SUBJECT: Forwards addl info required for cooling tower rept review,
 per NRC 800909 request. Oversize drawing available in
 Central Files.

Re: Nine Mile Point Unit 2
Docket No. 50-410

Additional Information Required For
The Cooling Tower Report Review

FIGURE 1
 NATURAL DRAFT COOLING TOWER
 GENERAL ARRANGEMENTS
 NINE MILE POINT NUCLEAR STATION-UNIT 2
 NIAGARA MOHAWK POWER CORPORATION

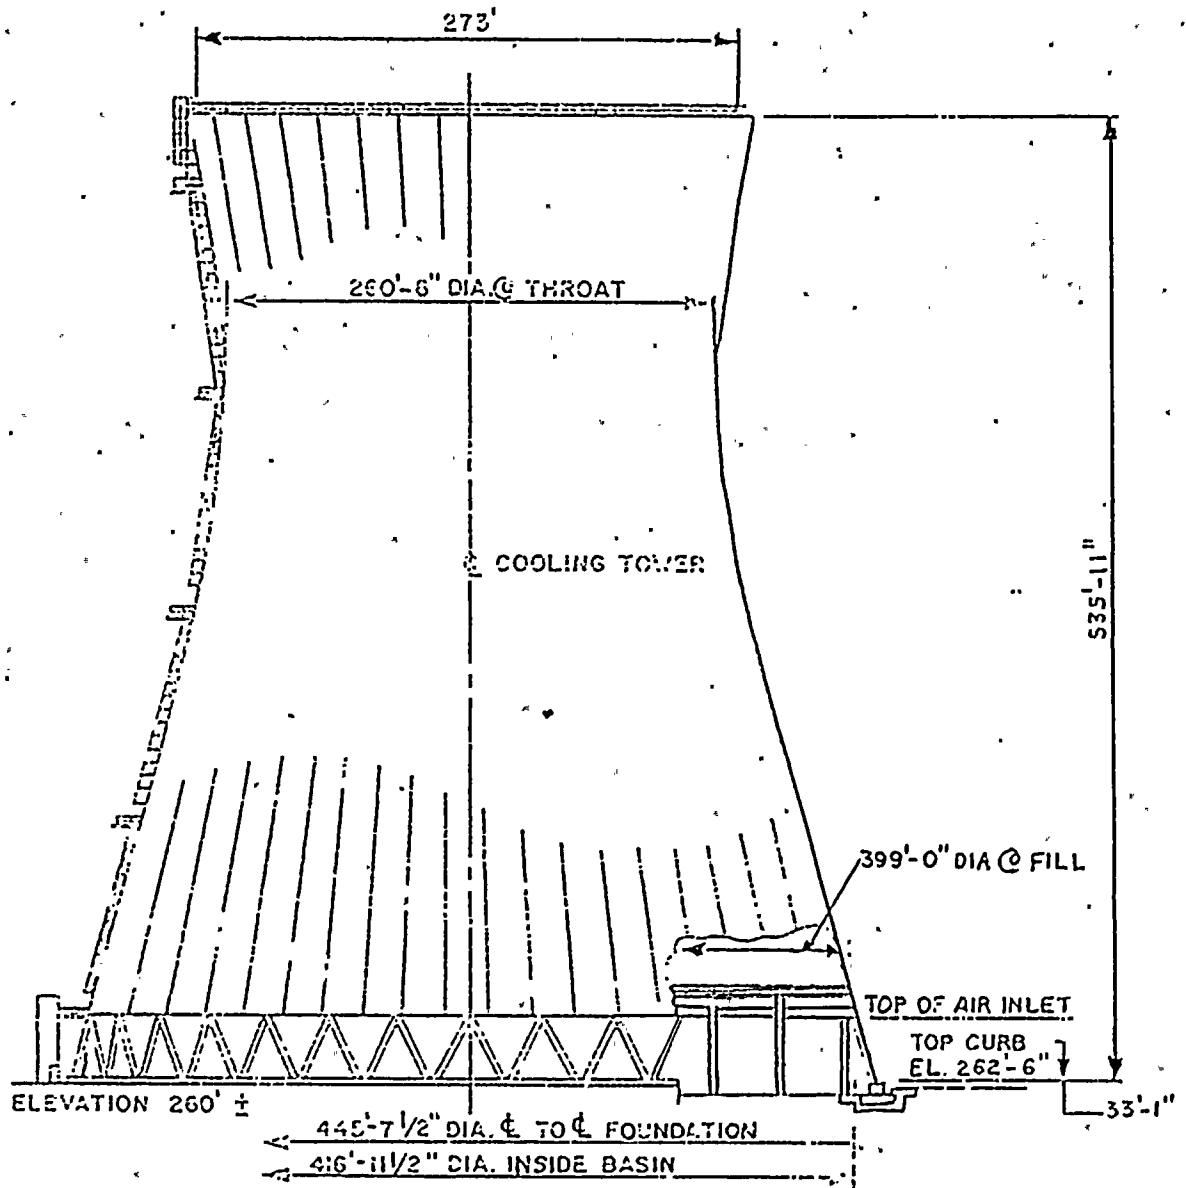
Update the Cooling Tower Report, dated July 19, 1976, with respect to major design changes of the cooling tower system as described in sections 2.0 and 3.0 of your report. Specifically, provide cooling tower dimensions, location, flow rates, atmospheric design conditions, a description of the circulating water treatment system, and other major design information that has changed since the report issuance.

Figure 1, Natural Draft Cooling Tower General Arrangement provides updated cooling tower dimensions.
